APPLICATION FOR DEVELOPMENT OF COMMUNITY IMPACT (DCI)

Chamblee Park

Revise the site plan of the approved PUD Master Plan to reconfigure two multi-family buildings to allow for a change

in building footprint and architectural details; and 2) convert some of the stacked flat residential buildings to townhomes.

Multifamily areas (see attached “Exhibit of Changes to Site Plan” marked in red)

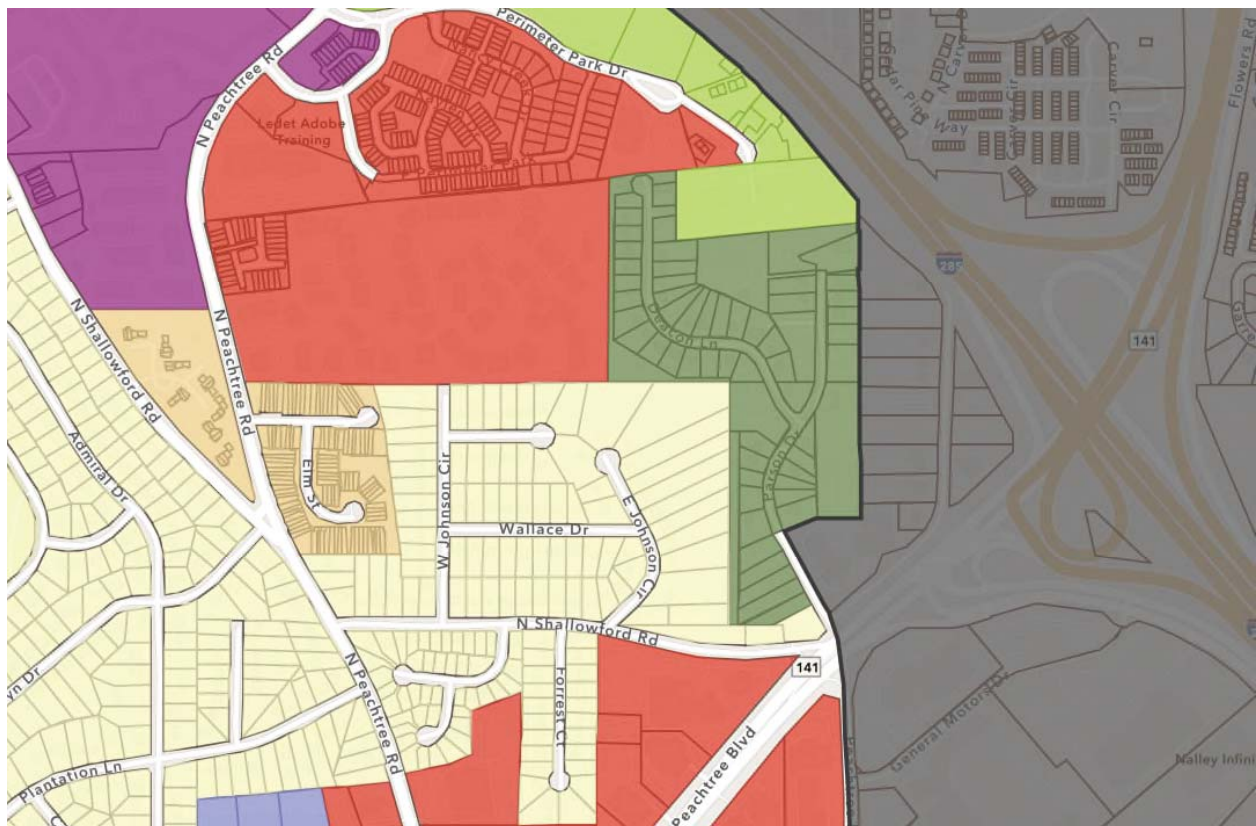
- Remove structured parking decks for both buildings and replace with standard surface parking.
- Reduce unit count to 300 multifamily units.
- Revise retaining walls in the northeast corner of the multifamily building to the east of Parsons Drive. Retaining walls were formerly integrated into the parking deck.
- One driveway marginally adjusted further southwest.

- Footprints and locations of both buildings have remained the same facing Parsons Dr
- Streetscape and landscape along Parsons Dr has remained the same.
- Building heights will remain the same.

- Replace condo units with three units in each building with single townhomes
- Group single townhome units in smaller groups with more space between each group.

- Locations of buildings have remained the same facing Parsons Dr
- Streetscape and landscape along Parsons Dr has remained the same.
- Building heights will remain the same
